## NE8MC\* – Facelift

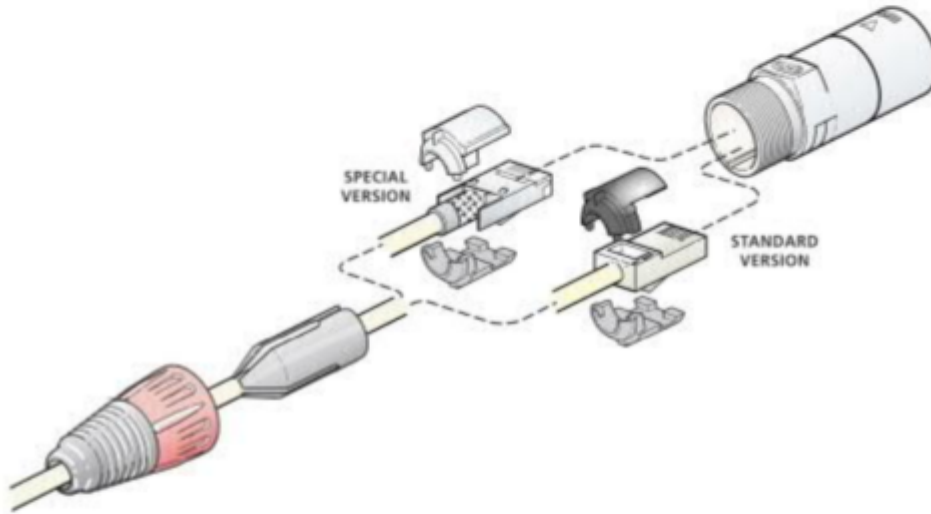
In order to provide a perfect fit for the vast amount of different RJ45s available on the market we have redesigned the alignment parts and simultaneously improved the positioning of the RJ45 connectors inside the etherCON cable carrier.

By help of the new alignment system we now support a greater range of RJ45 plugs while in parallel the improved positioning grants a smooth mating with the corresponding etherCON receptacle. Additionally we significantly eased the assembly of the connector since the chuck now clasps around both alignment parts and so it is very convenient to insert the assembly group into the housing.
